STATE OF TENNESSEE DEPARTMENT OF TRANSPORTATION

INSTRUCTIONAL BULLETIN NO. 17-07

Regarding Revised Standard Drawings

Effective August 18th, 2017 letting (June 7th, 2017 Turn-in), the following Standard Drawings have been revised to add item numbers and/or a General Note: "See TDOT Roadway Design Guidelines Section 4-716.11 for line width and Section 4-716.30 for material type."

TRAFFIC CONTROL FOR ONE LANE (RIGHT OR LEFT) CLOSURE FOR BRIDGES ON DIVIDED HIGHWAYS

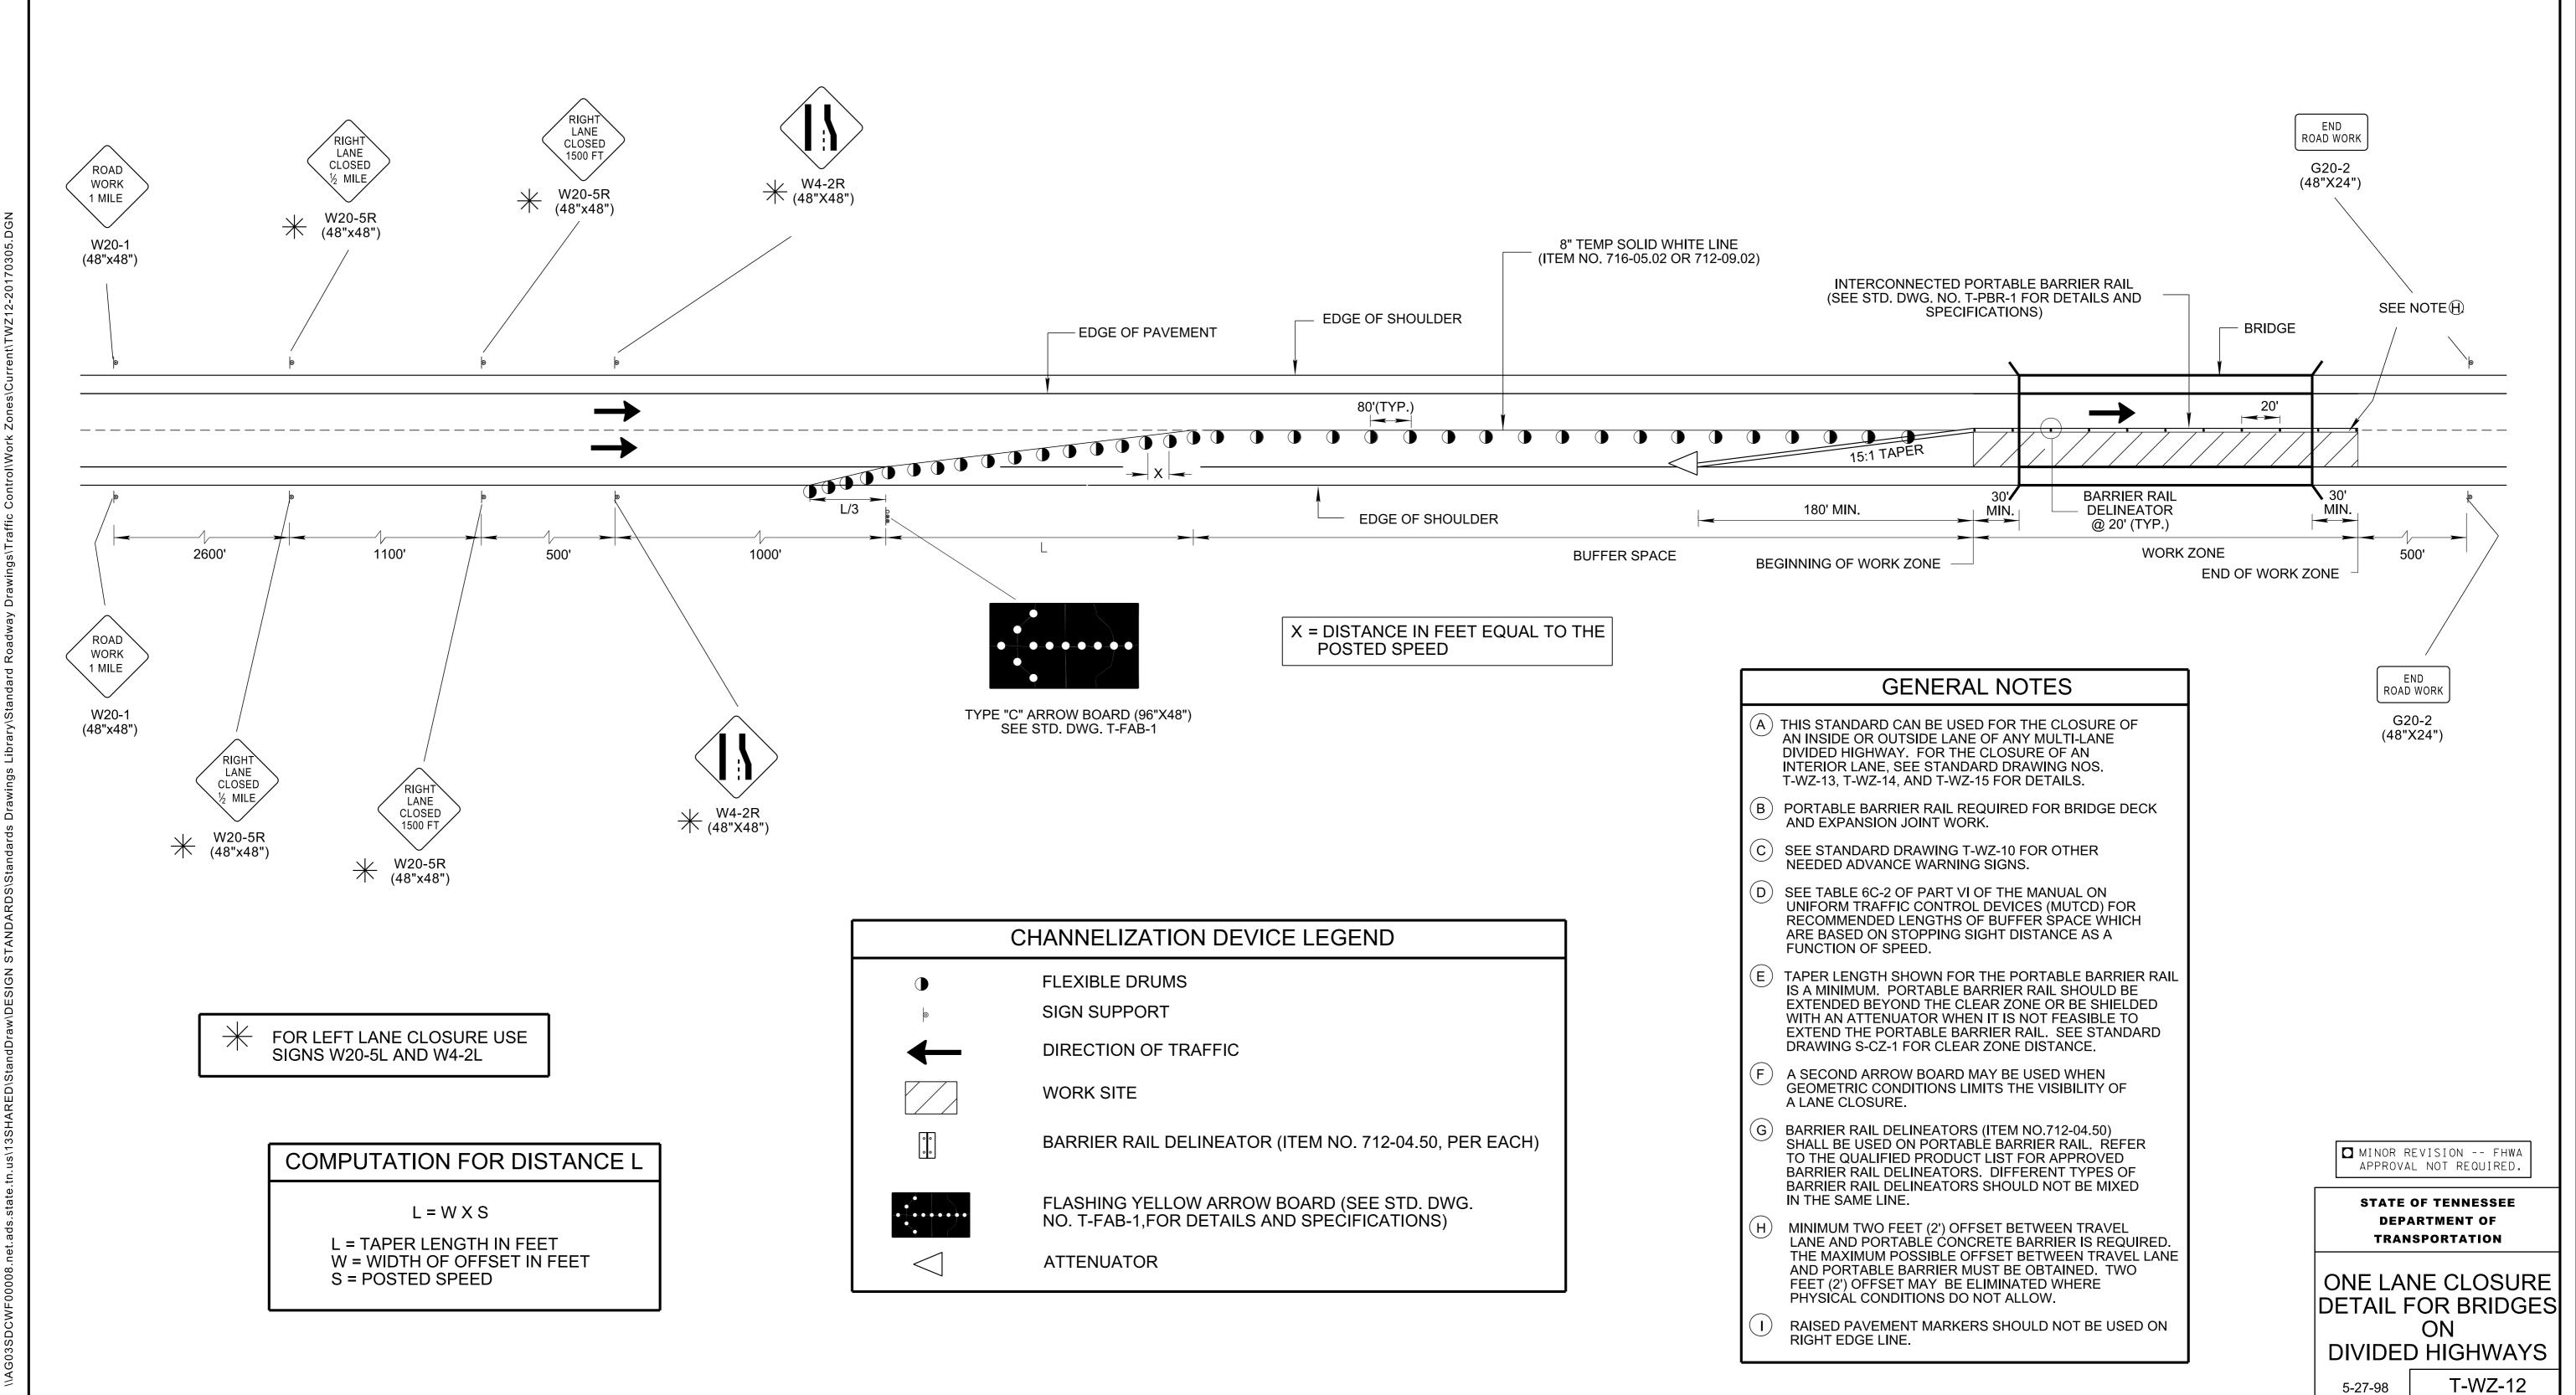
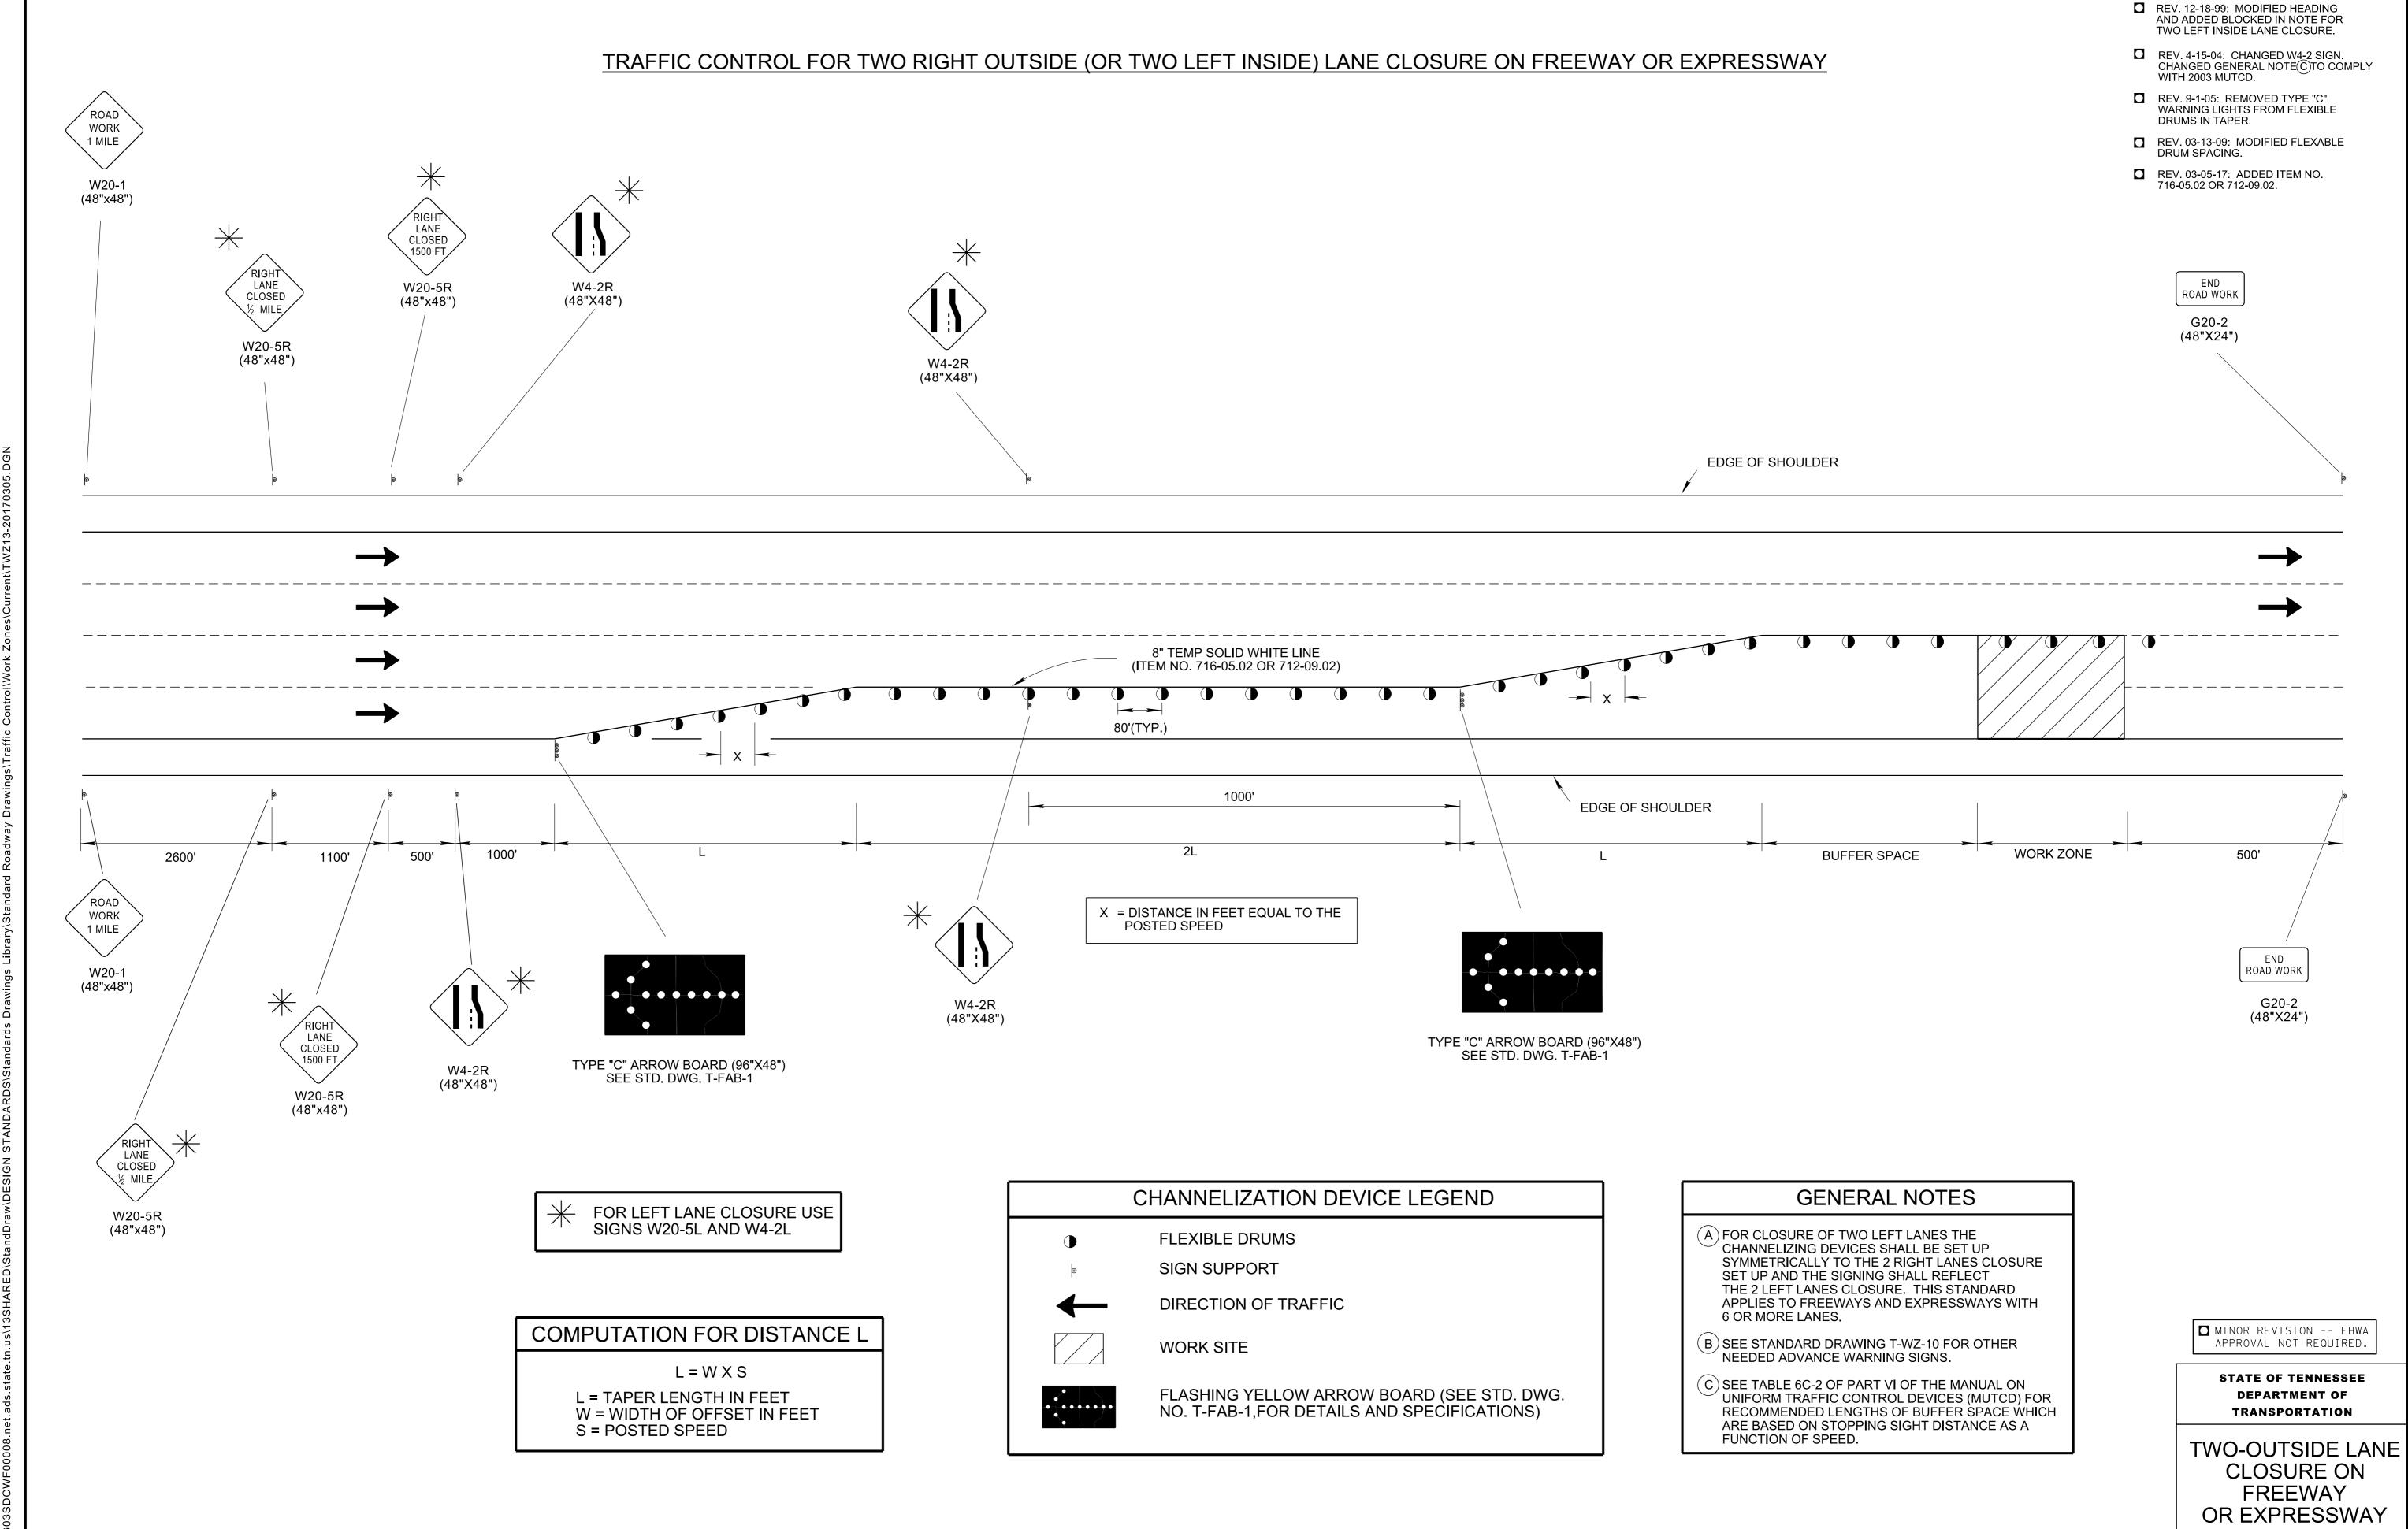
- REV. 10-06-06: CHANGED ITEM NO. FOR BARRIER RAIL DELINEATOR. ADDED GENERAL NOTE I. CHANGED GENERAL NOTE (E.)
- REV. 03-13-09: CHANGED GENERAL NOTE EAND ATTENUATOR LEGEND DESCRIPTION.
- REV. 03-05-17: ADDED ITEM NO. 716-05.02 OR 712-09.02.
- REV. 4-15-99: ADDED GENERAL NOTE(F)
- REV. 12-18-99: MODIFIED GENERAL NOTE(E)
- REV. 7-29-03: CHANGED GENERAL NOTE(E)
